ATA Security feature Set Clarifications

To: T13 Technical Committee
From: Jim Hatfield
Seagate Technology
(with Jeff Wolford: Hewlett-Packard)
389 Disc Drive
Longmont, CO 80503
Phone: 720-684-2120
Fax: 720-684-2722
Email: James.C.Hatfield@seagate.com
Date: October 24, 2006

The purpose of this proposal is to clarify a number of vague and unspecified issues regarding the ATA Security **Mode** feature set. This is the source of unpredictable behavior between vendors and models currently in the market. Locking down the specification of ATA Security is critical to ensuring reliable interoperability.

Figure 1 - Security State **Mode** Diagram

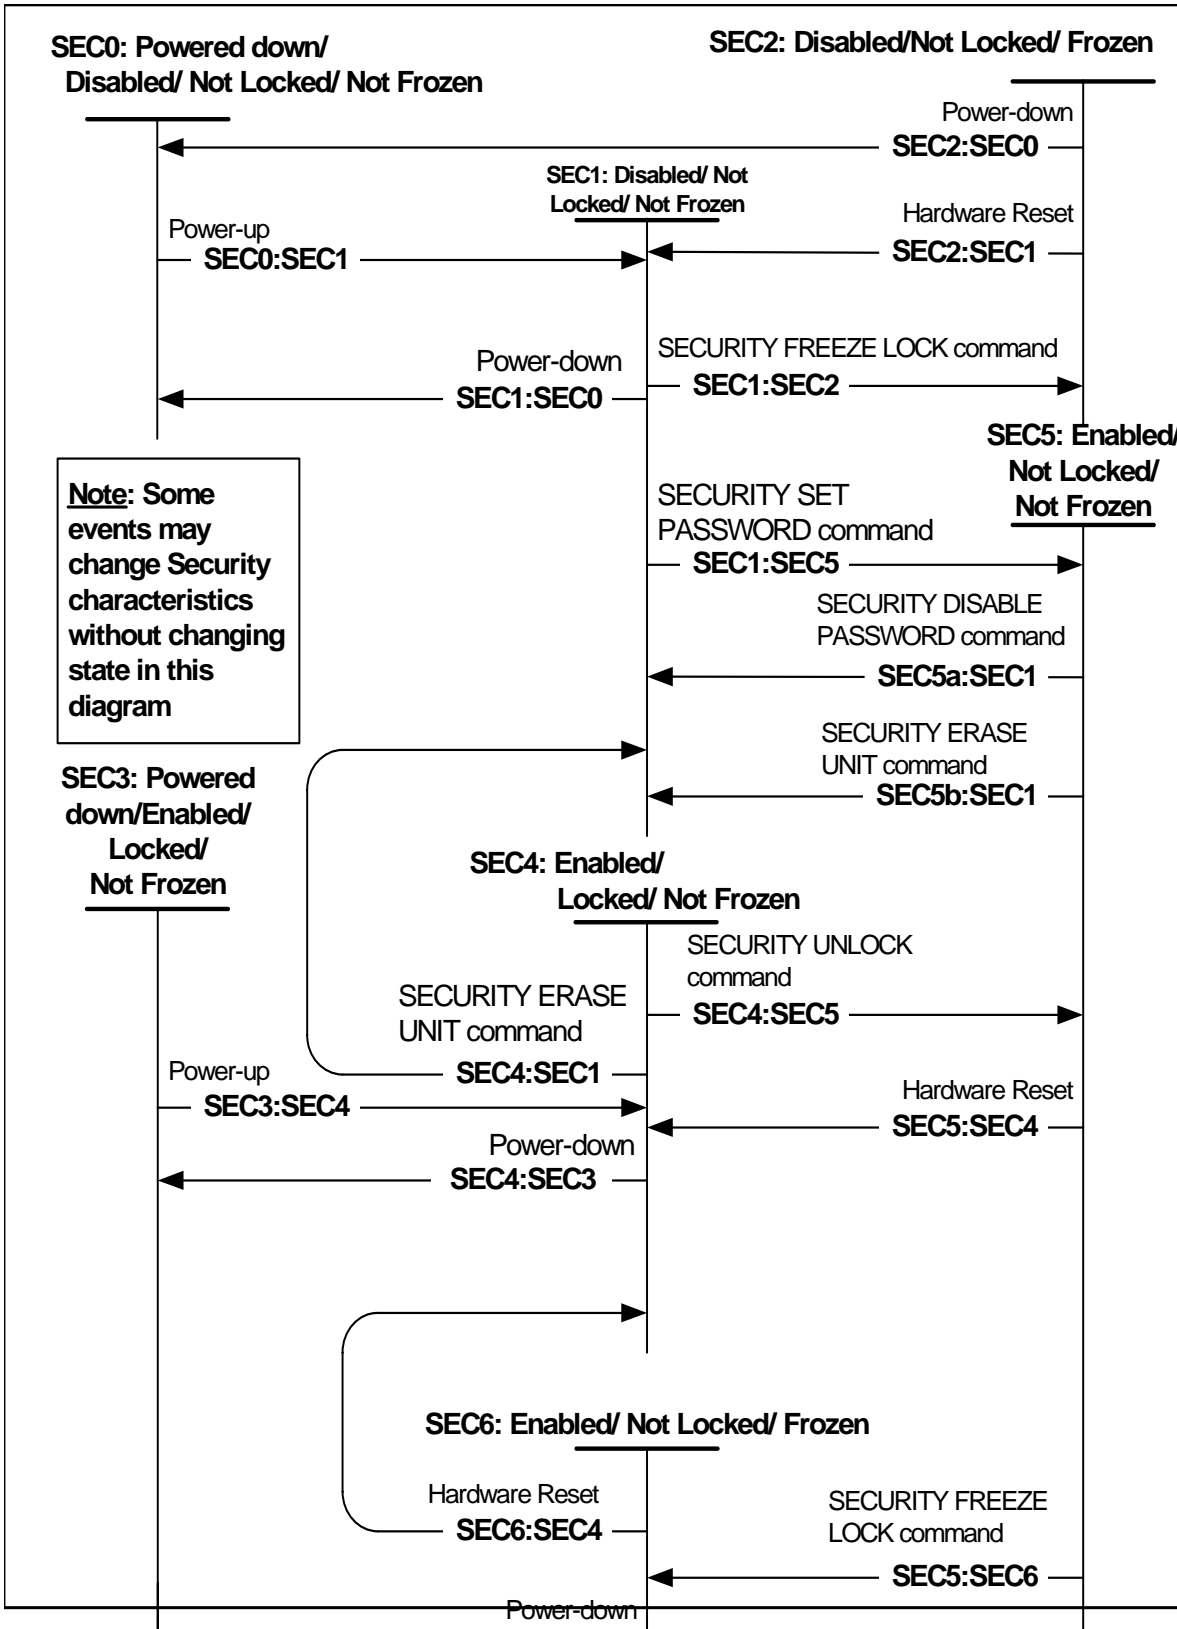
- 9) In the text following the state diagram, shall each reference to each state name ALSO have the tags “enabled/locked/frozen”, etc. that is appropriate to each state ?

- a. Resolution: do not keep all the tags with each reference
- 10) Incorporate the Visio version of the state diagram
- a. Resolution:
